Site Plan - Subdivision 106 - Heatherstone Drive		
Heatherstone Village - Painesville Twp.		
SCALE: 1" = 20	APPROVED BY	DRAWN BY Q.S.H.
DATE: 11-27-90	Q. Himebaugh	
Prepared by Himebaugh & Associates 38083 West Spaulding St. Willoughby, Ohio		
216-946-1761		DRAWING NUMBER 90-101-106

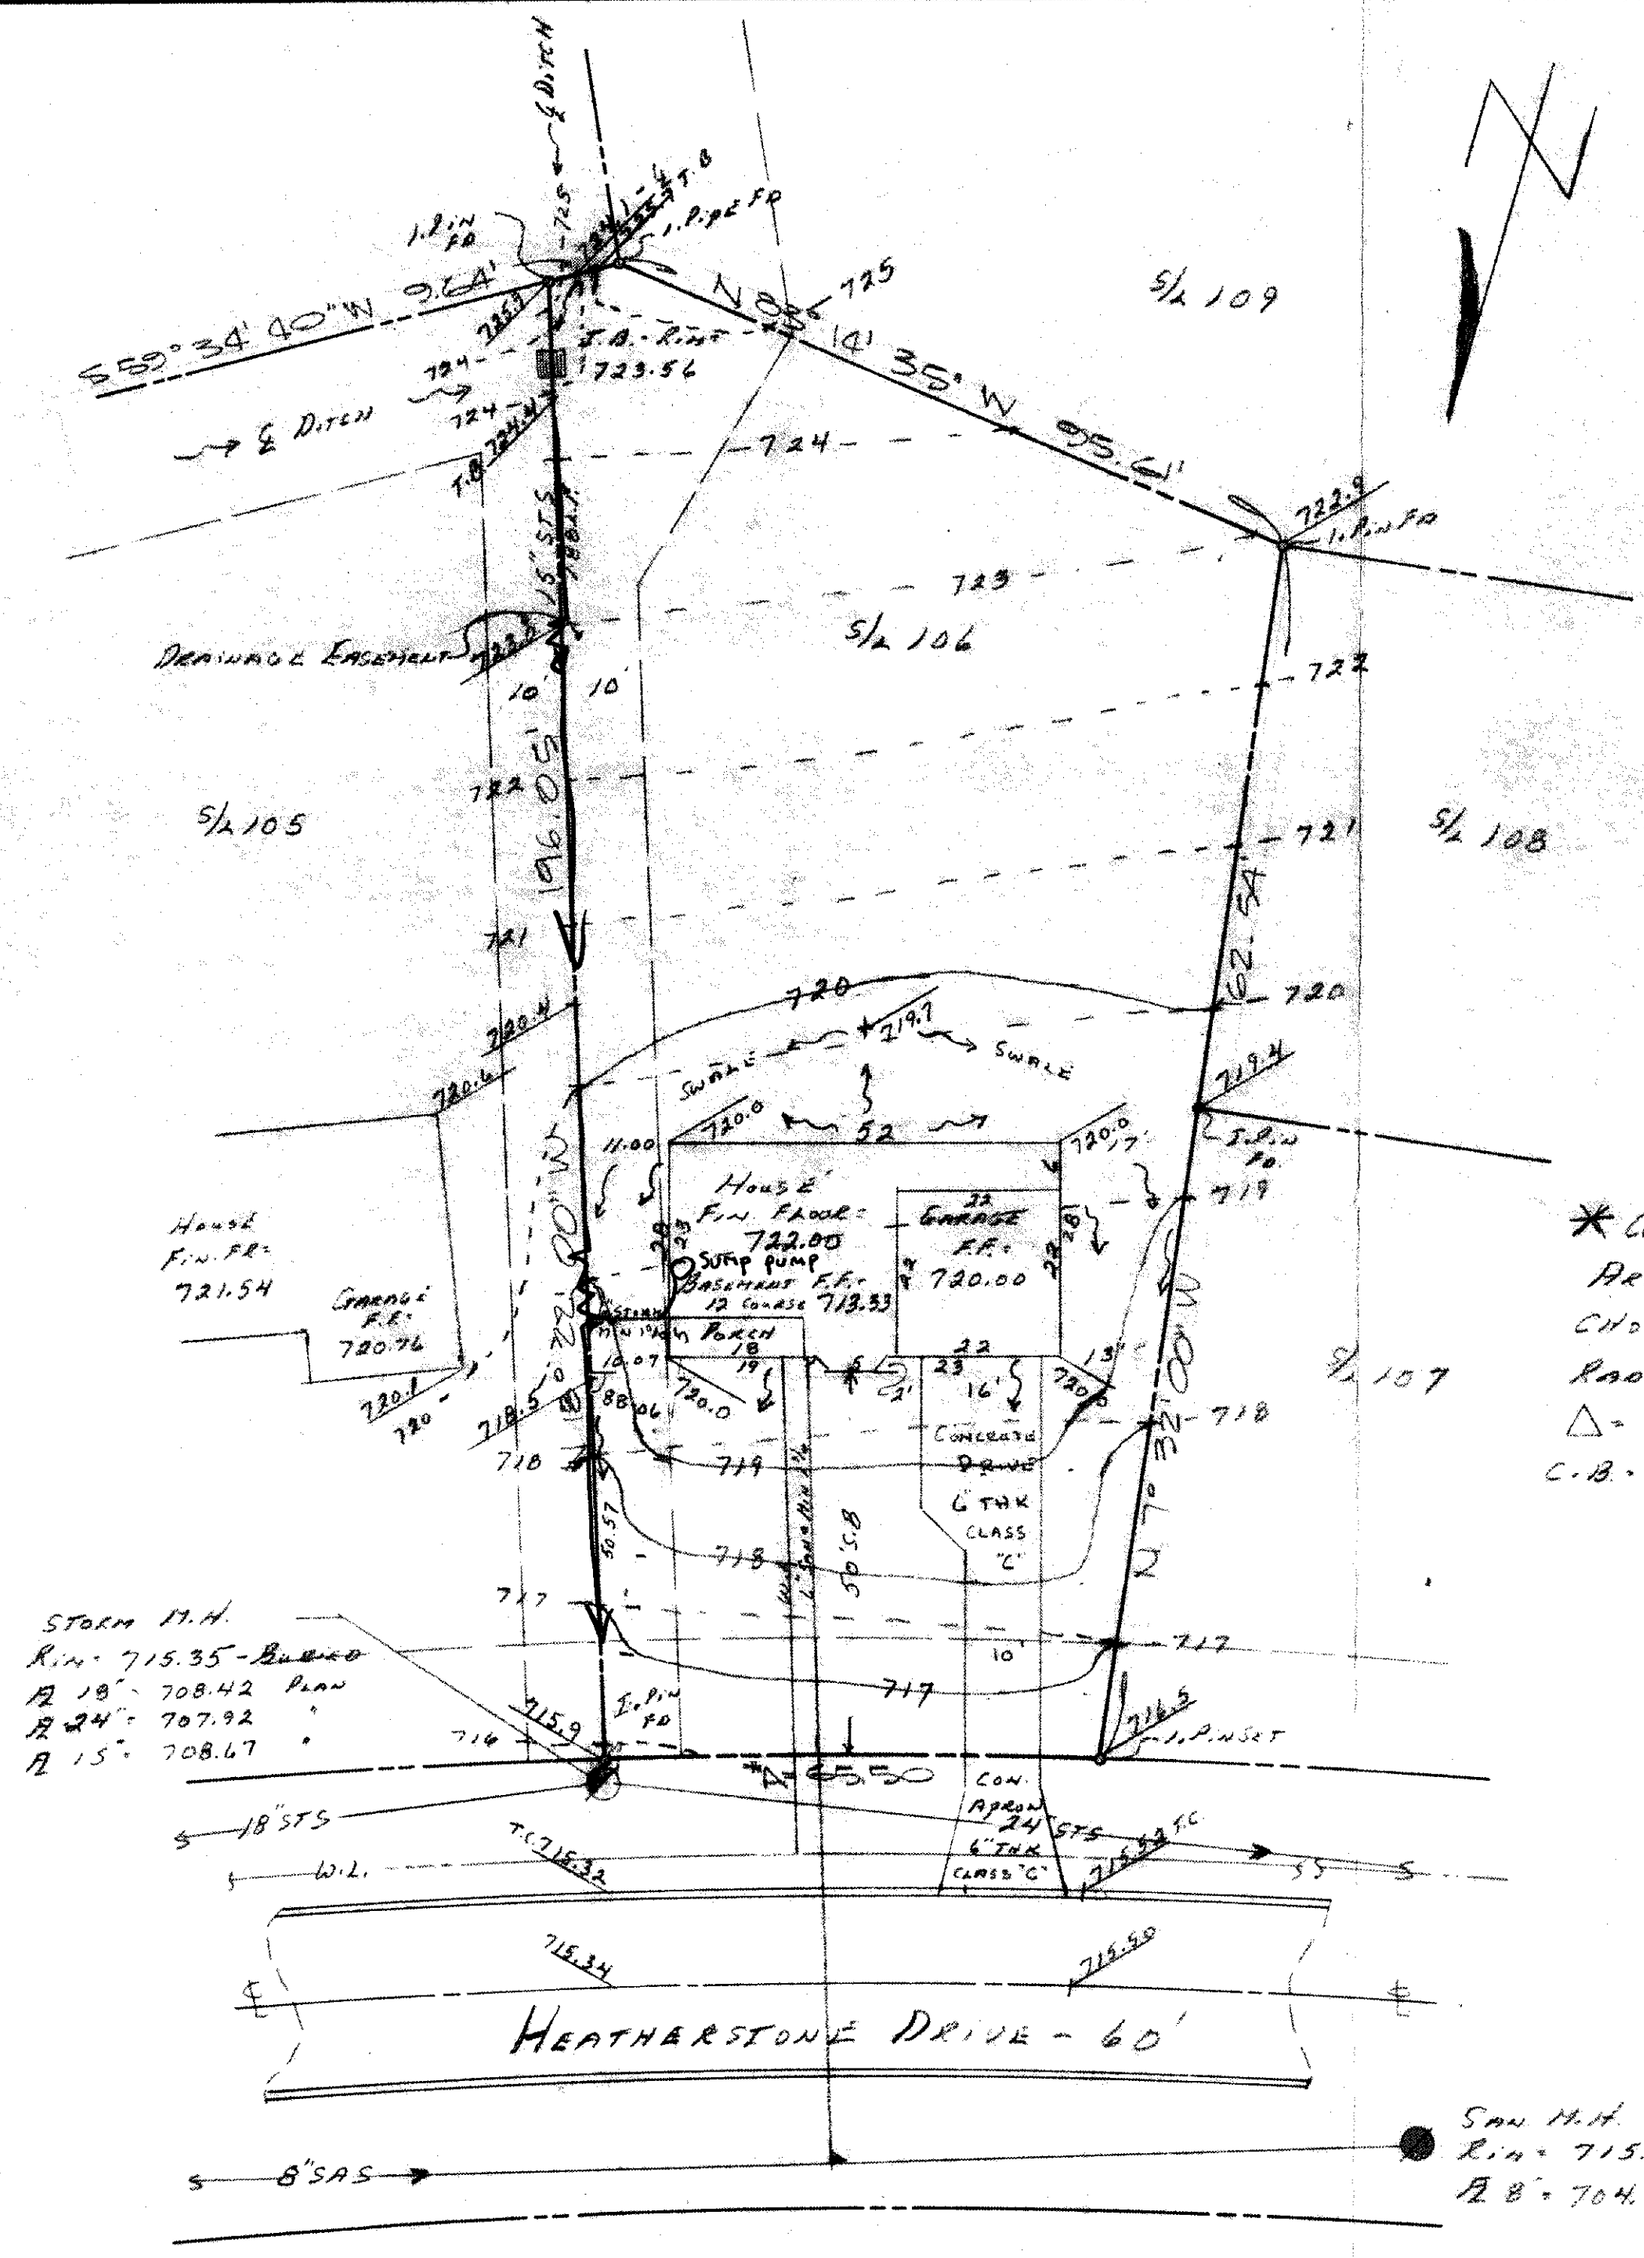
1. Sump pump required, discharge to 15" storm
2. Down spouts to splash blocks
3. Swale along east property line.

Note: Location storm lateral S/L 106 - Unknown
Connect storm into 15" storm on property line S/L 105-106.
